Arboricultural Impact Assessment (AIA) Notes:

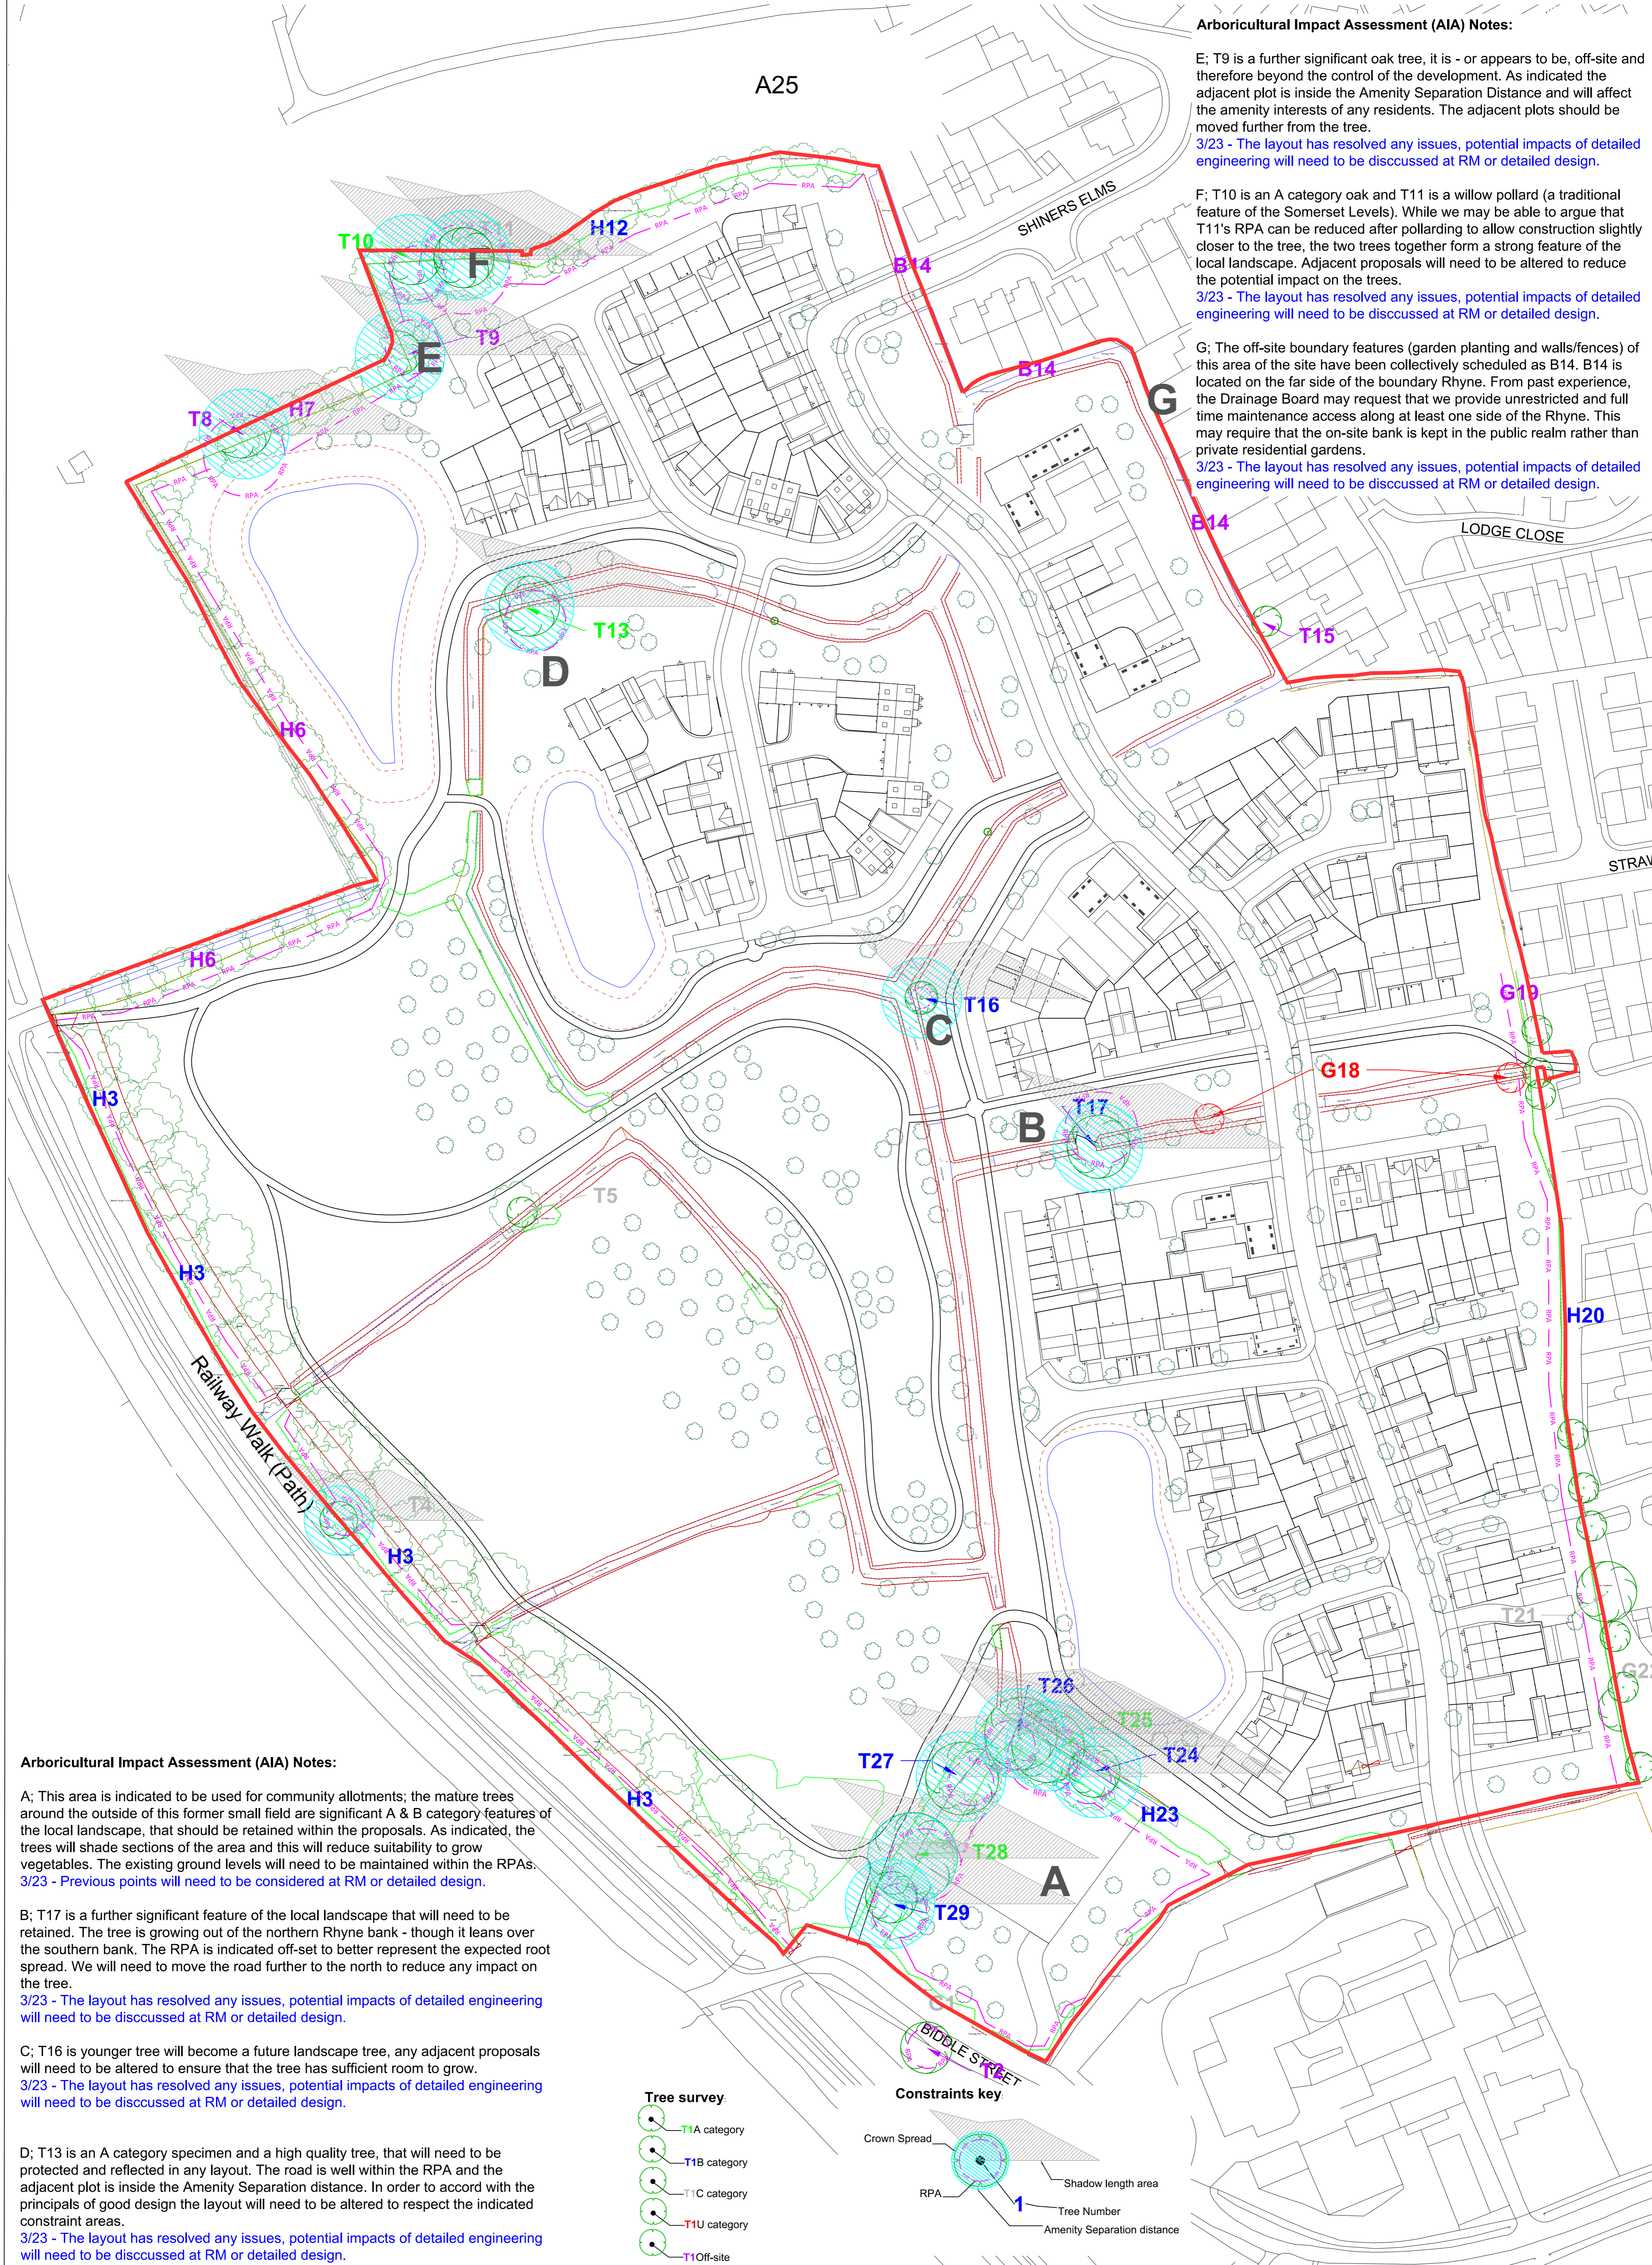
E; T9 is a further significant oak tree, it is - or appears to be, off-site and therefore beyond the control of the development. As indicated the adjacent plot is inside the Amenity Separation Distance and will affect the amenity interests of any residents. The adjacent plots should be moved further from the tree.

F; T10 is an A category oak and T11 is a willow pollard (a traditional feature of the Somerset Levels). While we may be able to argue that T11's RPA can be reduced after pollarding to allow construction slightly closer to the tree, the two trees together form a strong feature of the local landscape. Adjacent proposals will need to be altered to reduce the potential impact on the trees.

G; The off-site boundary features (garden planting and walls/fences) of this area of the site have been collectively scheduled as B14. B14 is located on the far side of the boundary Rhyne. From past experience, the Drainage Board may request that we provide unrestricted and full time maintenance access along at least one side of the Rhyne. This may require that the on-site bank is kept in the public realm rather than private residential gardens.

A; This area is indicated to be used for community allotments; the mature trees around the outside of this former small field are significant A & B category features of the local landscape, that should be retained within the proposals. As indicated, the trees will shade sections of the area and this will reduce suitability to grow vegetables. The existing ground levels will need to be maintained within the RPAs.
3/23 - Previous points will need to be considered at RM or detailed design.

B; T17 is a further significant feature of the local landscape that will need to be retained. The tree is growing out of the northern Rhyne bank - though it leans over the southern bank. The RPA is indicated off-set to better represent the expected root spread. We will need to move the road further to the north to reduce any impact on the tree.
3/23 - The layout has resolved any issues, potential impacts of detailed engineering will need to be discussed at RM or detailed design.

C; T16 is younger tree will become a future landscape tree, any adjacent proposals will need to be altered to ensure that the tree has sufficient room to grow.
3/23 - The layout has resolved any issues, potential impacts of detailed engineering will need to be discussed at RM or detailed design.

D; T13 is an A category specimen and a high quality tree, that will need to be protected and reflected in any layout. The road is well within the RPA and the adjacent plot is inside the Amenity Separation distance. In order to accord with the principals of good design the layout will need to be altered to respect the indicated constraint areas.
3/23 - The layout has resolved any issues, potential impacts of detailed engineering will need to be discussed at RM or detailed design.

3/23 - The layout has resolved any issues, potential impacts of detailed engineering will need to be discussed at RM or detailed design.

3/23 - The layout has resolved any issues, potential impacts of detailed engineering will need to be discussed at RM or detailed design.

3/23 - The layout has resolved any issues, potential impacts of detailed engineering will need to be discussed at RM or detailed design.
